UNITED STATES PATENT AND TRADEMARK OFFICE

APPLICATION NO.	FILING DATE	FIRST NAMED INVENTOR	ATTORNEY DOCKET NO.	CONFIRMATION NO.
10/644,729	08/21/2003	Takefumi Suzuki	000560-00123	6194
27557	7590	09/17/2004	EXAMINER	
BLANK ROME LLP 600 NEW HAMPSHIRE AVENUE, N.W. WASHINGTON, DC 20037			SHAKERI, HADI	
			ART UNIT	PAPER NUMBER
			3723

Office Action Summary	Application No.	Applicant(s)	
	10/644,729	SUZUKI, TAKEFUMI	
	Examiner	Art Unit	
	Hadi Shakeri	3723

DETAILED ACTION

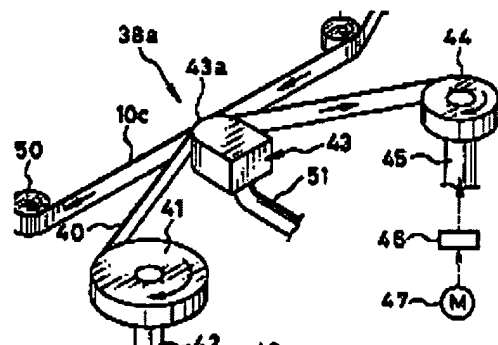
Applicant may wish to rewrite the claims into Jepson type claims, since the device for correction of metal rings' peripheral length (i.e., items 2-4 in Fig. 1, including movable driven roller) is old as admitted by the applicant and since the improvement to the prior art device is the addition of item (5).
